SUBJECT: James A. FitzPatrick Nuclear Power Plant
Docket No. 50-333
**Response to NRC Request for Additional
Information Concerning GE SIL 630 (TAC No. MB1020)**

**Response to NRC June 26, 2001 Request for Additional Information
Concerning GE SIL 630 (TAC No. MB1020)**

Entergy Nuclear Operations Inc.
James A. FitzPatrick Nuclear Power Plant
Docket No. 50-333

Figure 1 of JPN-00-039

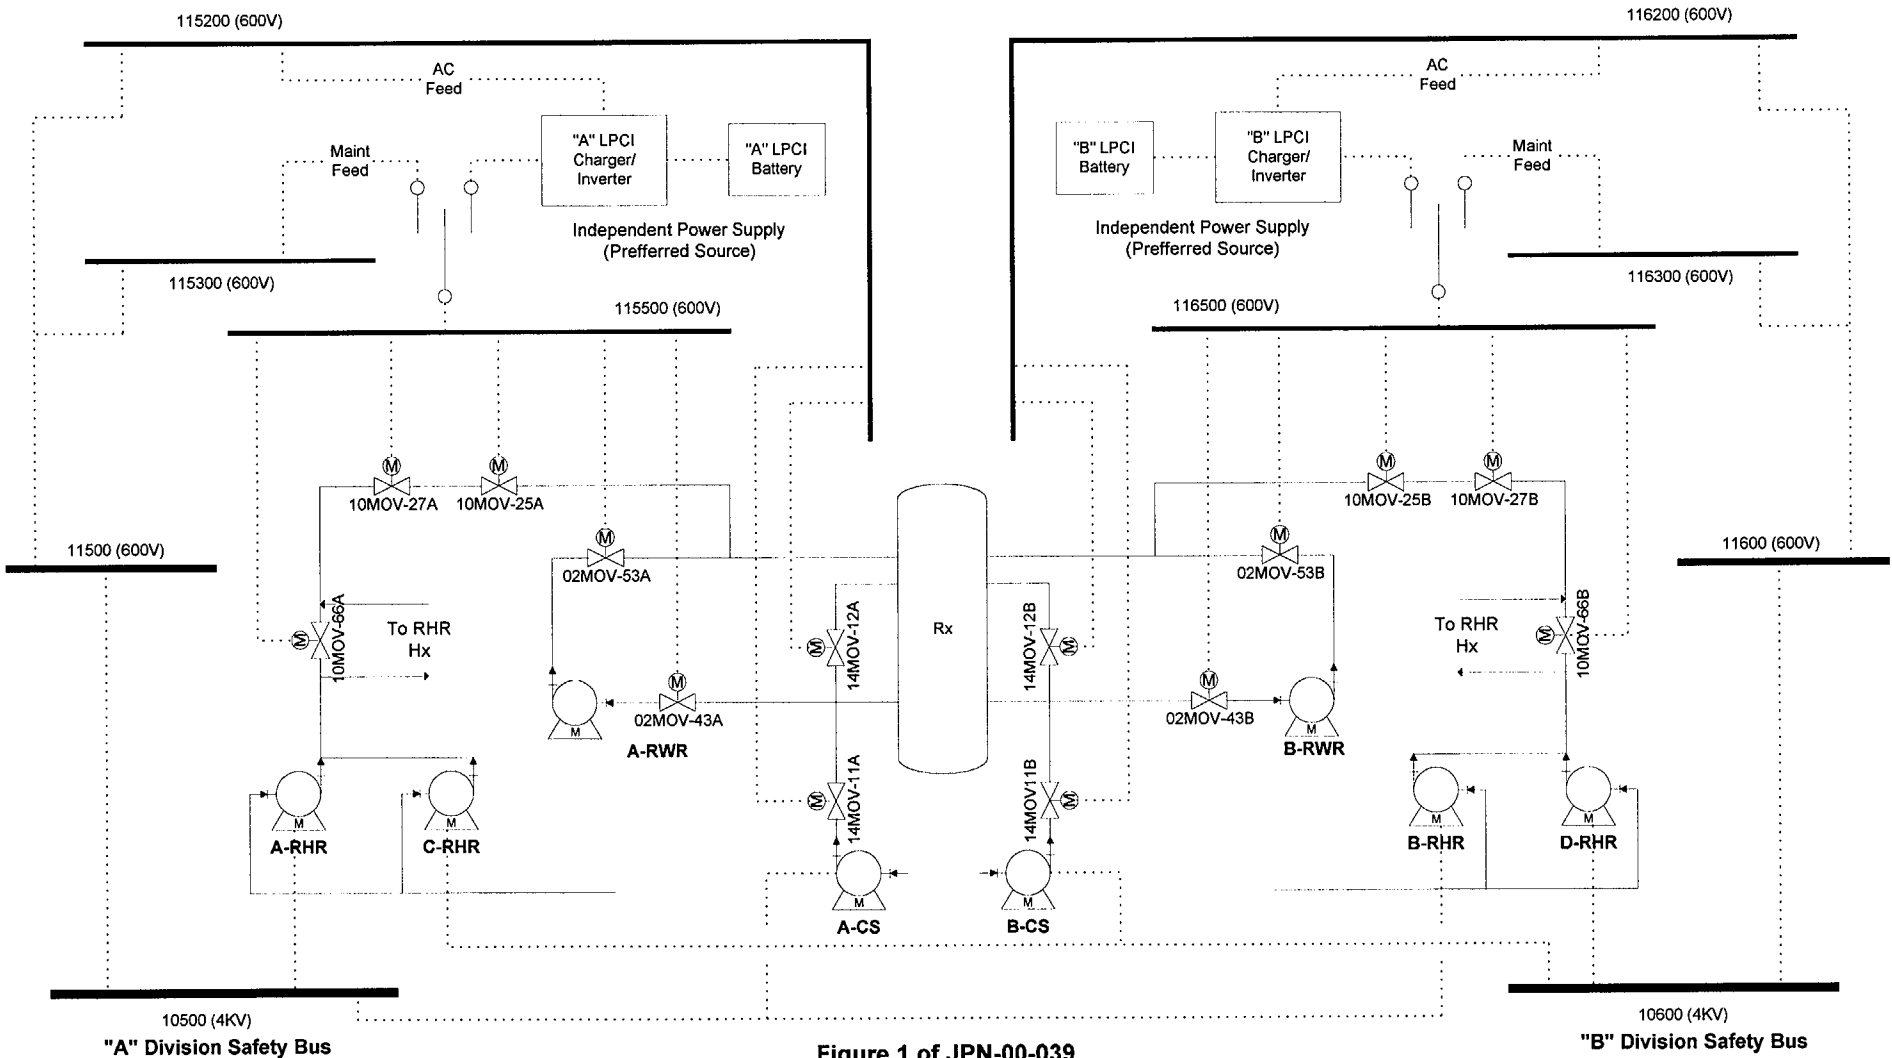
Additionally, are power cables of all low-pressure emergency core cooling systems (ECCS) routed in such a manner that a failure of any wireway that carries these cables would not result in a reduction in ECCS capacity below the level assumed in the FitzPatrick loss-of-coolant accident analysis?

NYPA's October 12, 2000 response (Reference 4) to NRC Questions 2, 3 and 4 describe electrical power arrangements for FitzPatrick's Core Spray (CS) pumps, low-pressure injection pumps (LPCI), and injection valves. Figure 1 of Reference 4 shows the power configuration for LPCI and CS. (A copy of this figure has been included as Attachment 2.) The table in Response 4 indicates which components share raceways for some portion of the routing of their power cables. This table has been reproduced in Table 1.

The separation of cables into the seven "raceway groups" described by Table 1 was a consequence of the arrangement of the components in the plant. In general, the use of "raceway groups" to assure the availability of ECCS equipment is not a requirement of the FitzPatrick design or licensing bases. Raceway groups were used to illustrate the extent of cable separation, e.g. that the loss of any single raceway group (1-7) would only affect those components in that group and would not result in a reduction in ECCS capability below the level assumed in the FitzPatrick loss-of-coolant analysis.
